Hilfield Solar Farm and Battery Storage Facility

Statement of Common Ground - Noise

LPA Reference: 21/0050/FULEI (Hertsmere Borough Council)

RE: Hilfield Solar Farm. Additional Information re Noise.

FIGURE 1: R1 AERIAL VIEW

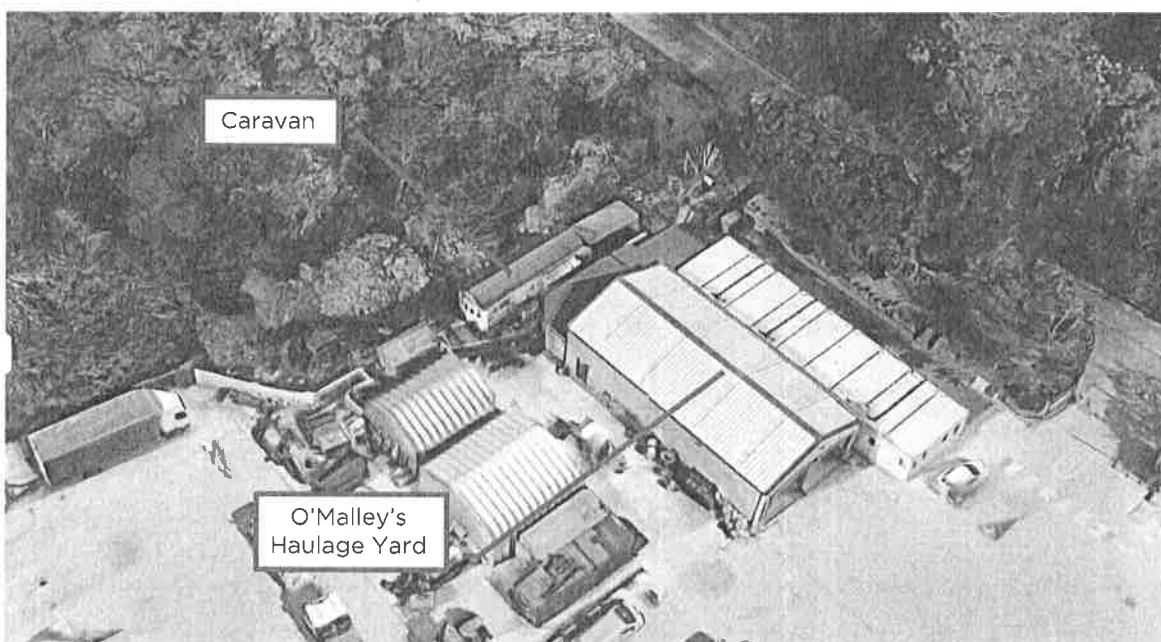
As discussed in our telephone call, the receptor R1 is heavily screened by the built form of adjacent commercial buildings, as shown in Figure 1, below. The centre of the battery energy storage area is some 170 m from R1.

Using iNoise, we have extracted the source to receiver attenuation factors, calculated in accordance with ISO 9613, to enable the verification of the calculations. The battery energy storage area was modelled as a single point source, with appropriate corrections made for the quantity of HVAC fans etc.

The specific sound level at R1, from the battery energy storage at a height of 1.5 m above ground level, is therefore 16.6 dB.

The net effect of removing the screening from the calculations increases the predicted specific sound level at R1 from the battery energy storage area by some 13.2 dB.

It should be noted that, cumulatively from all noise sources associated with the proposed development, the specific sound level at 1.5 m is calculated to be 33 dB, and 35 dB at a height of 4.0 m, respectively when the buildings are removed from the noise model. As a result, the removal of the buildings from the calculation would not alter the conclusion of the noise assessment report in any way, with respect to complying with the requirements of BS4142:2014+A1:2019.

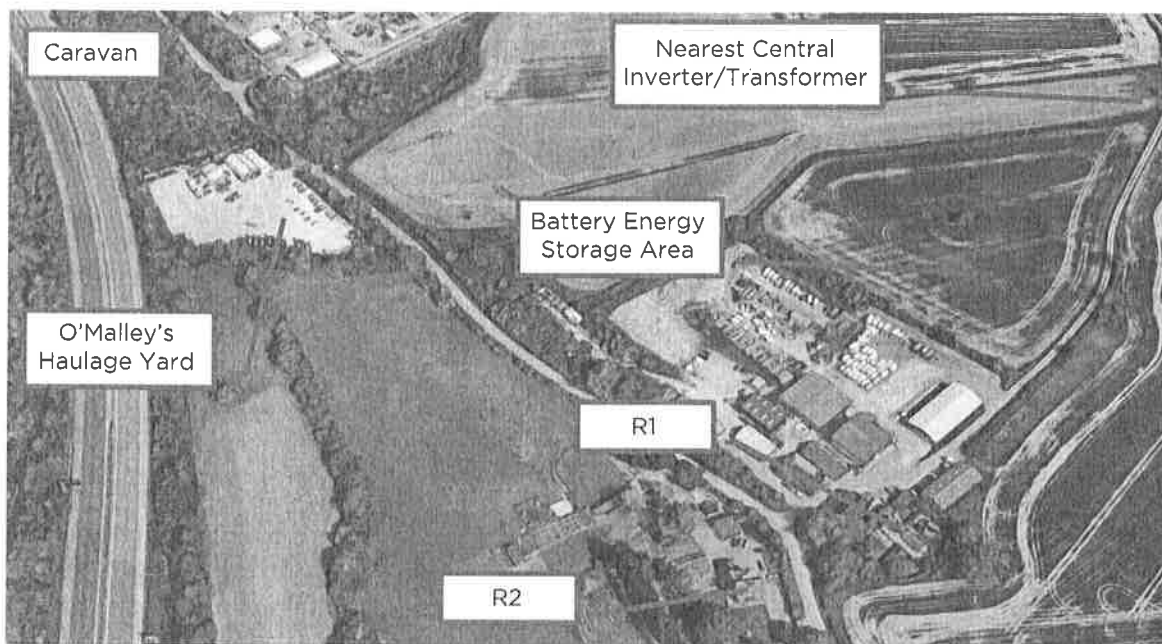
I understand that the caravan located to the rear of O'Malley's Haulage Yard was raised on the first day of the Public Inquiry, and a query was raised as to why this was not included in the noise assessment. I have elaborated on this point in the following text.

Please find attached a 3D aerial view of the caravan in question, relative to the proposed noise generating elements of the proposed development (battery energy storage area and central inverter/transformer stations). I appreciate the solar panels do encroach much further towards the caravan, but do not inherently generate any noise.

The caravan is screened by the built form of O'Malley's Haulage Yard, and the highest calculated rating sound level at the caravan is 25dB at a height of 1.5 m (as it is single storey unit), some 33dB below the daytime background noise level, and 26dB below the night time noise level. The caravan is in very close proximity to the M1, so the measurement position MP6 has been used to represent the background sound level at this property.

The margin of compliance is same as that demonstrated at R8 in the noise assessment report, i.e. this would be one of the least potentially affected receptors in the entire vicinity of the proposed development, and is therefore not a constraint with respect to noise, hence why it was not considered in the initial noise assessment.
